## Grandview Reserve Phase 2 Preliminary Drainage Report

December 2023

HR Green Development, LLC

EDARP Filing No.:  
PUDSP236

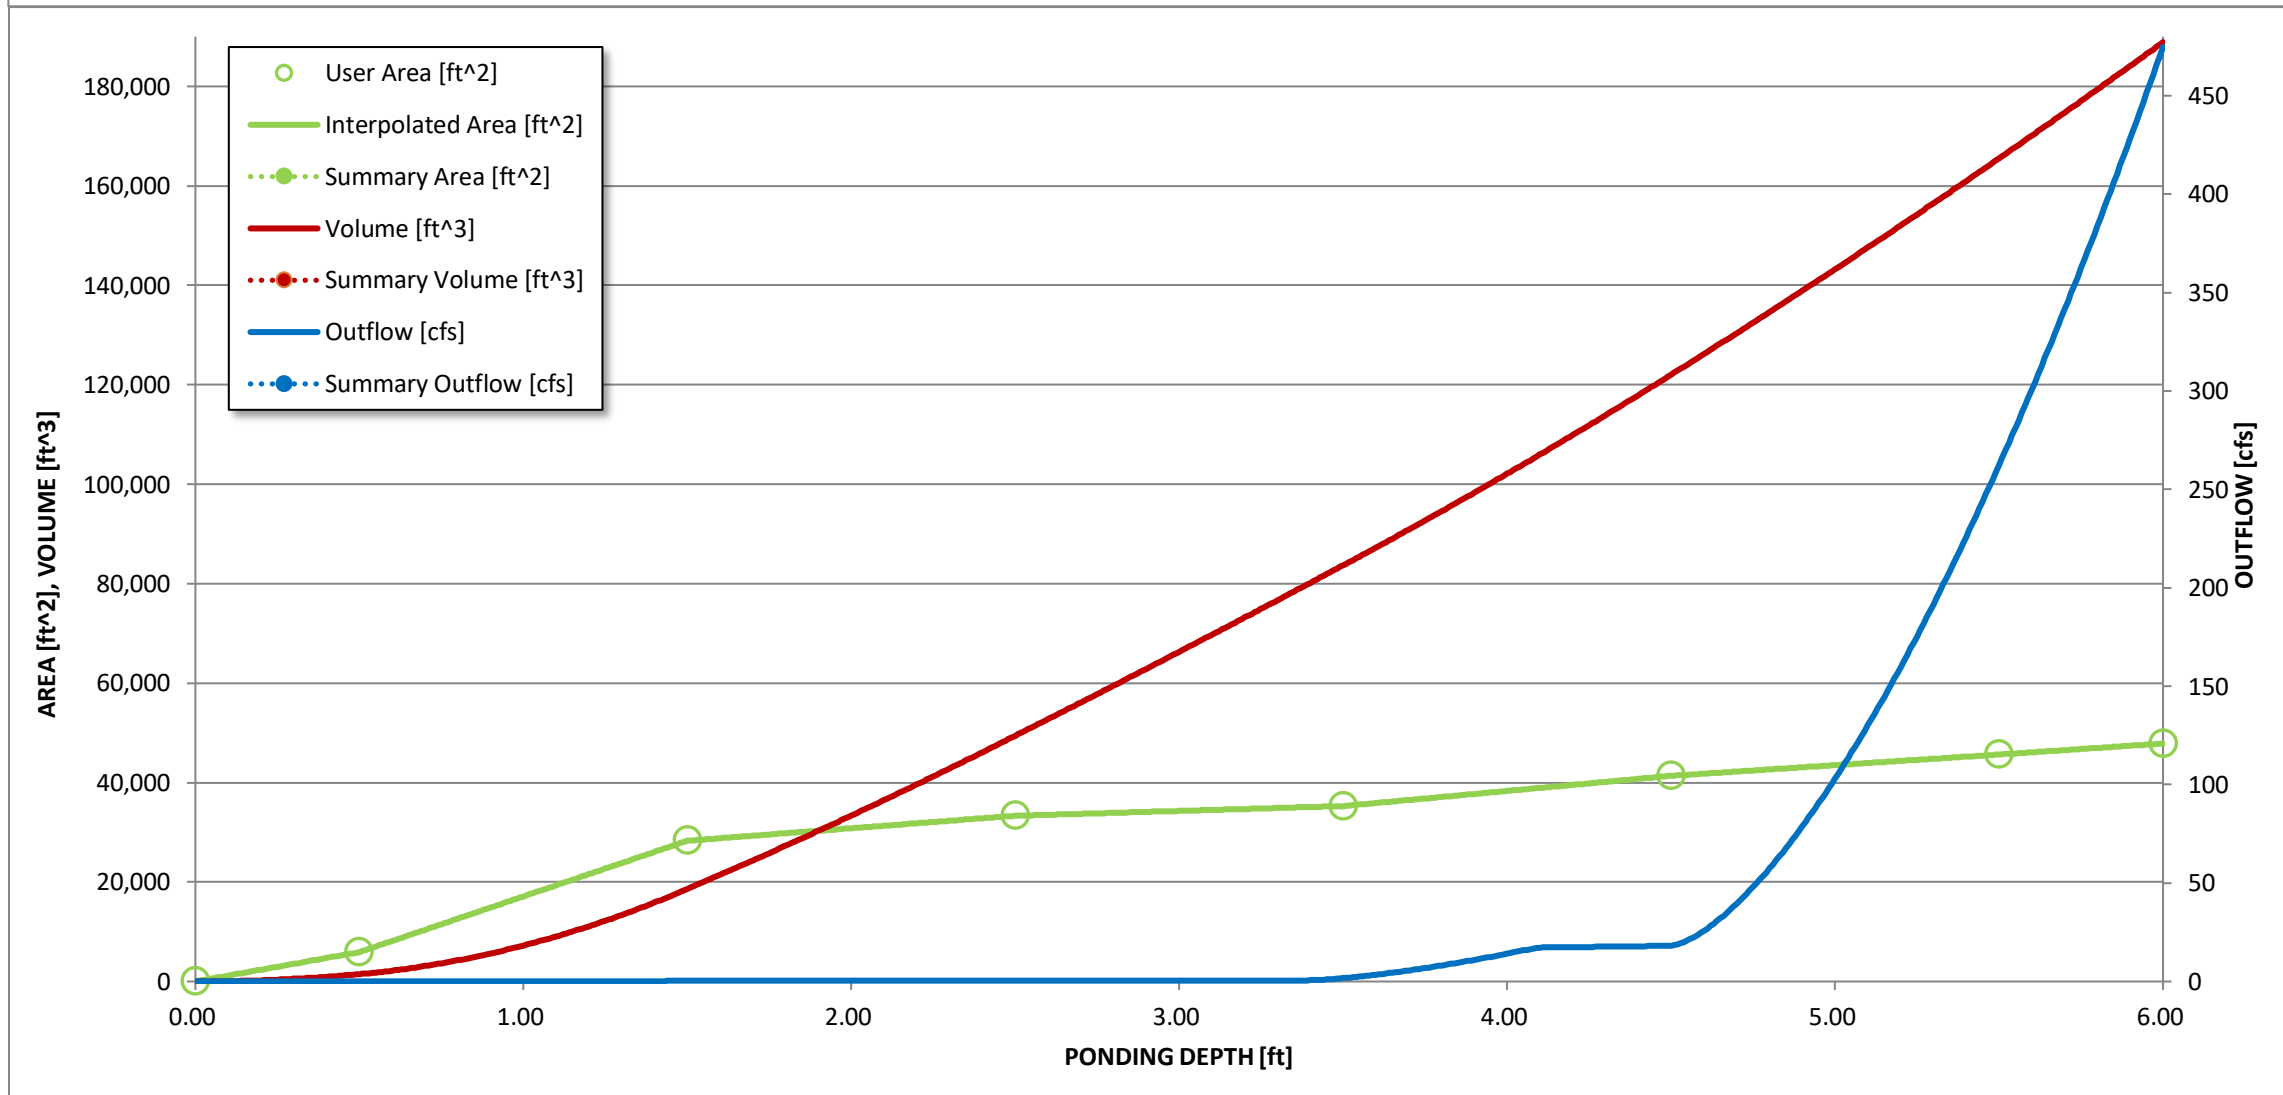
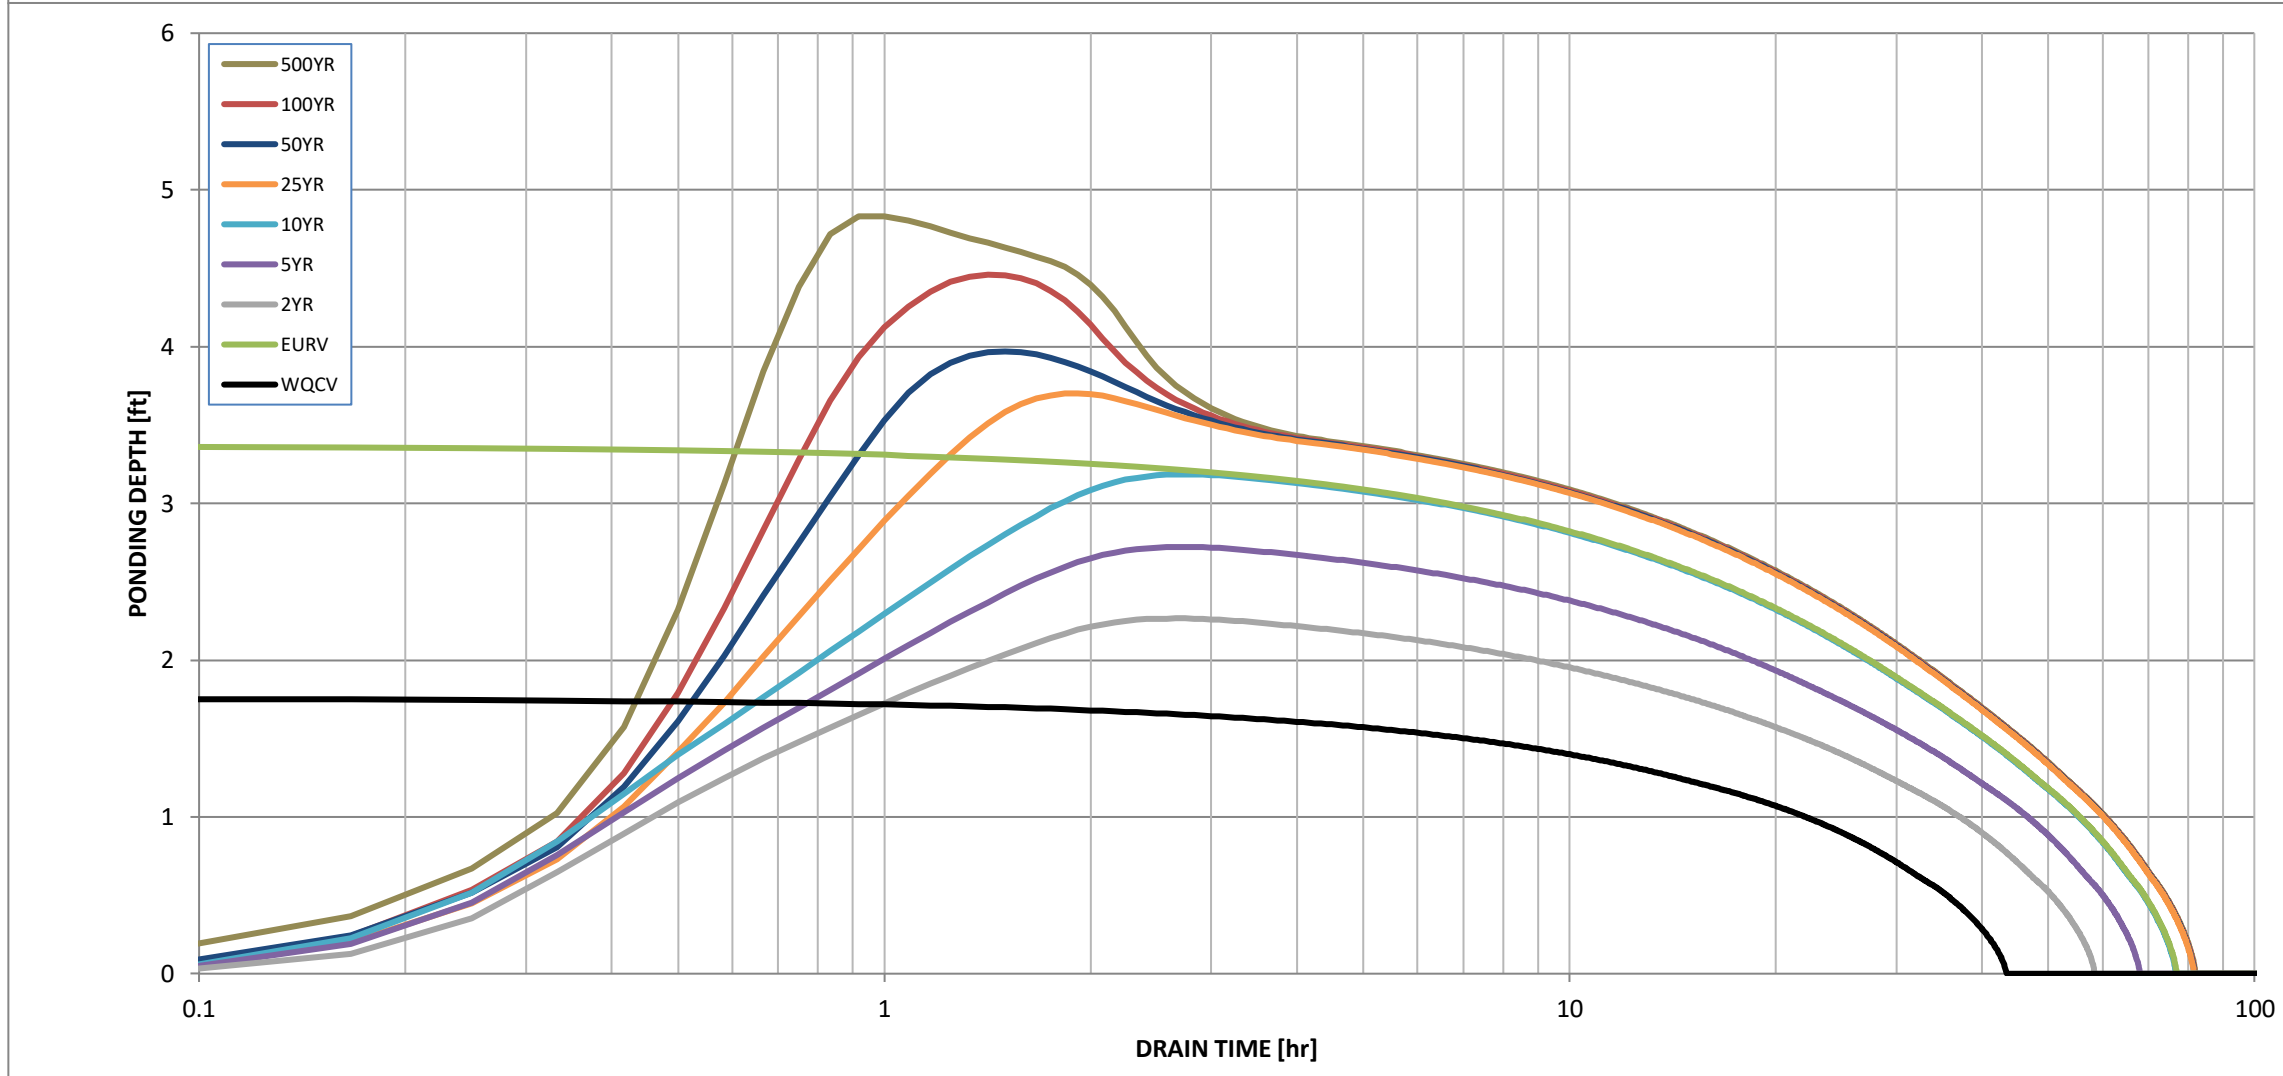
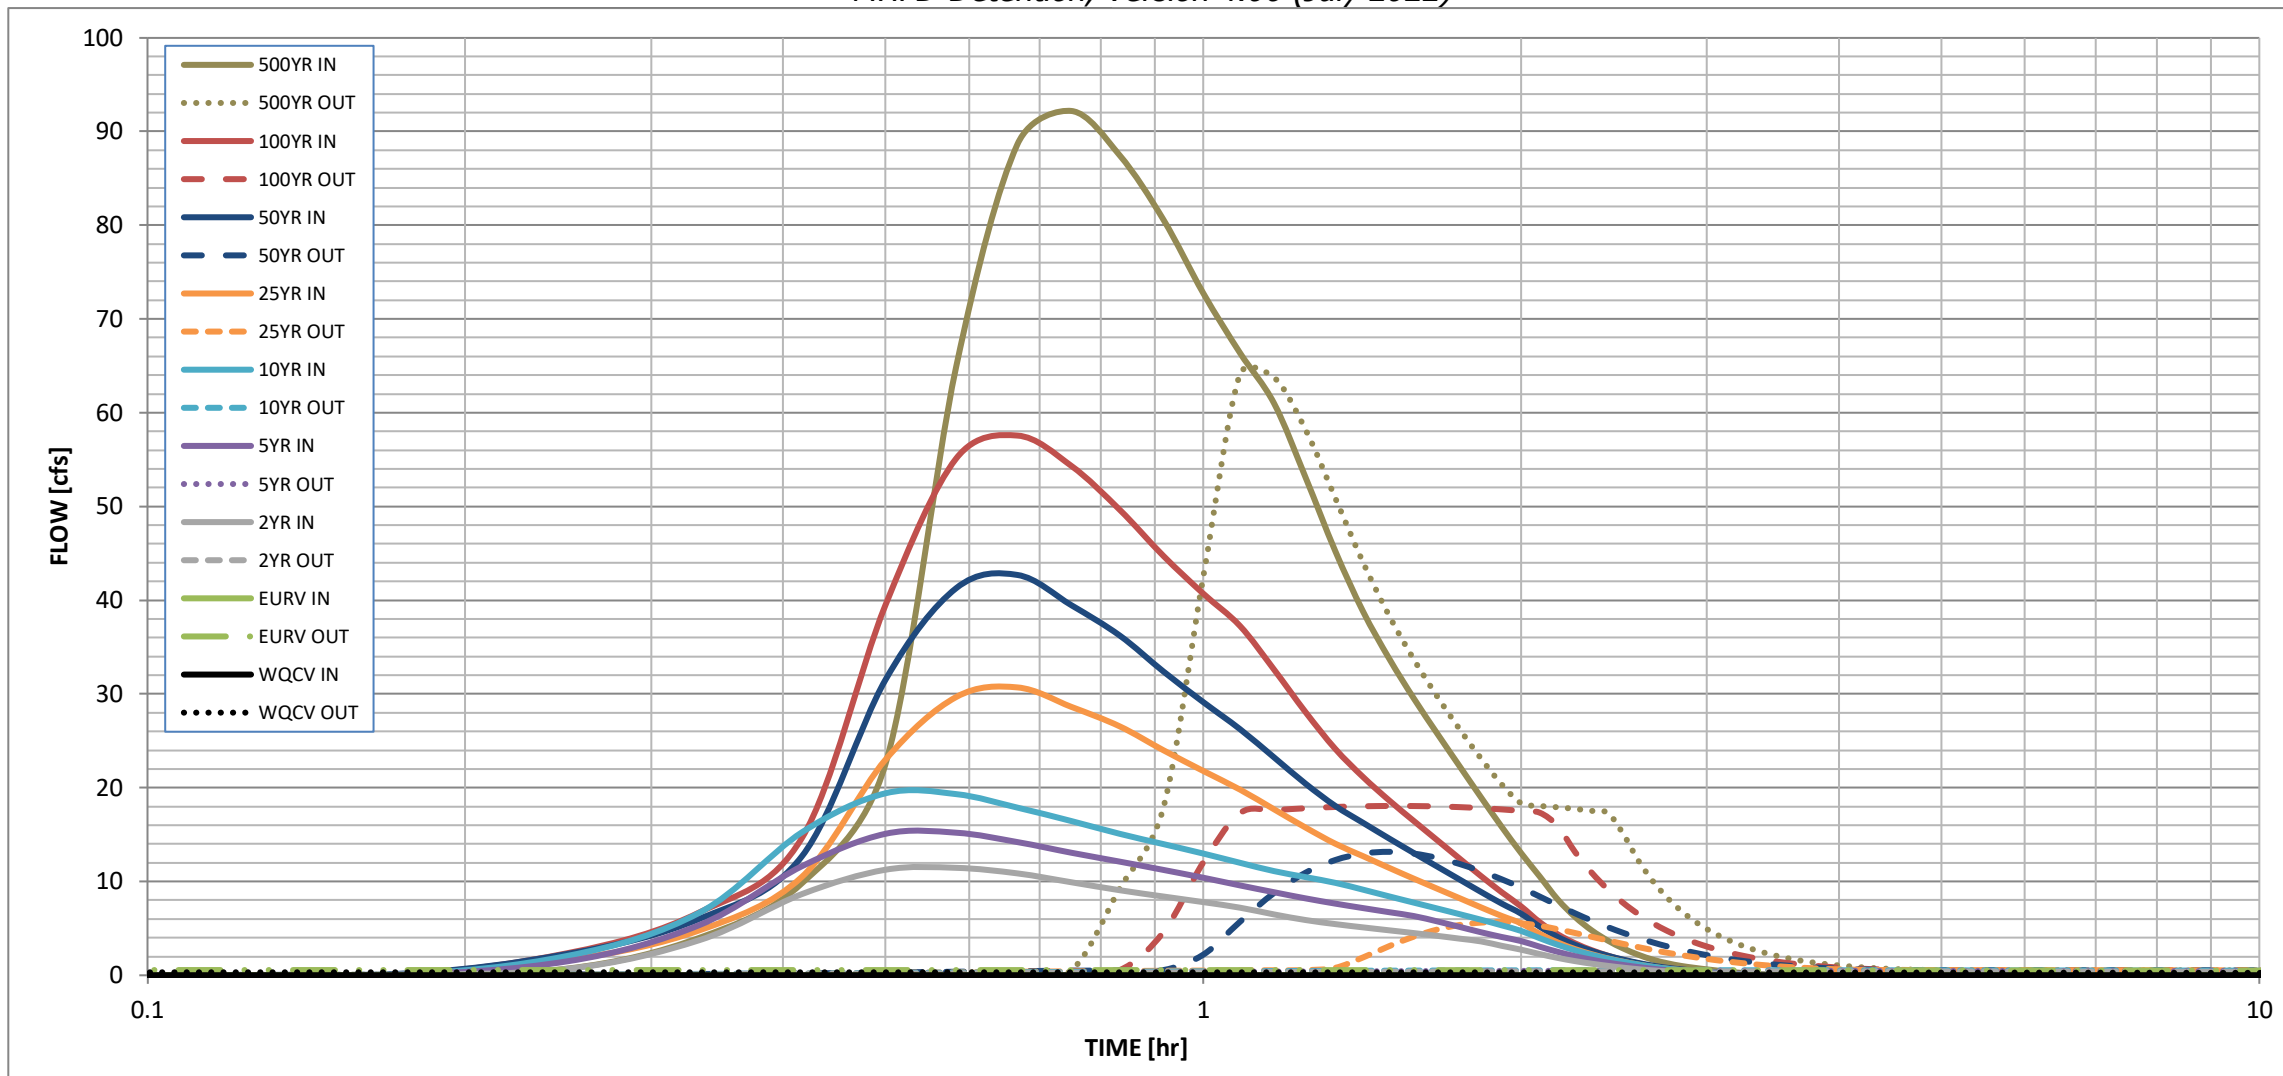
Q ratios should be less than or equal to 1.

**HR GREEN RESPONSE:**  
Justification for 5-yr and 100-yr release rates has been provided in the "Water Quality & Detention" Section of the PDR. Per coordination with Glenn Reese on 02.27.24 we will not be required to meet pre-development flows for storms in between the 5-yr and 100-yr event.
